PROGRESS MEETING MINUTES

Basin 4100 and DFA 0056 OSP
Monday, July 20, 2020
10:00-11:40 am Microsoft Teams

The meeting was held to discuss the conceptual design and report and direction for completing the project. While this summary is not intended to represent a comprehensive account of the meeting, it is intended to reflect the key points raised and issues for further consideration and to identify the action items resulting from the discussions.

Crossing Name: F

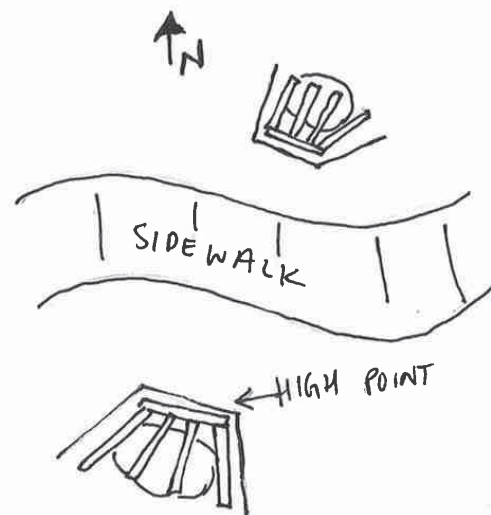
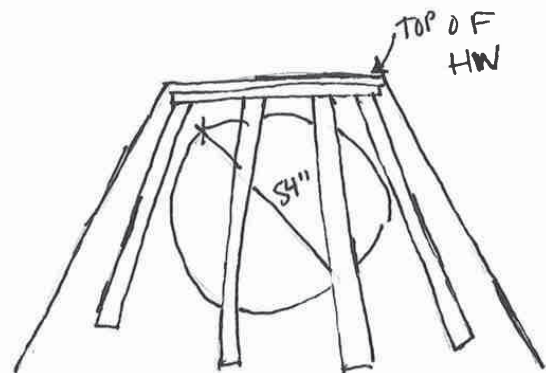
Jim Kaiser PDF pg 63: The Colorado Ag canal goes under the thalweg in a siphon; this "crossing info" must be a carryover from the previous MDP. That said, the trail crossing that goes "through" the siphon is a 1 36" (?) RCP on a sharp skew; making it a fairly long pipe. This should be updated in the table, if not the model, too. See photo 2020 07 09_092206

- The existing structure information is based on survey information. The original information provided to Olsson was for the Colorado Agricultural Ditch crossing, and not the drainageway crossing, see attachment "Crossing F. Thornton resurveyed the area and provided the updated survey, see attachment "Crossing F – Corrected". It reports dual 18-inch RCPs crossing underneath the canal. However, it appears that this information may be incorrect. When zoomed in on the photographs, it appears that the pipes may actually

be 30-inch RCPs. See Surveyor's photo below. Olsson confirmed during a site visit that the crossing is dual pipes. The size was not verified by Olsson during the site visit.

- Verify size?
 - Thornton will look for as-built information on this crossing, re-measure the size, and survey the trail for overtopping elevation.
 - Olsson will remove the recommendation for the two 42-inch pipes.
- If size is incorrect update existing and conceptual design? Alternatives models and information will not be updated.
 - A statement will be added in the conceptual design to document the the pipe size and note that it changed from the alternatives. The full report will be updated with exception of the alternatives analysis section.
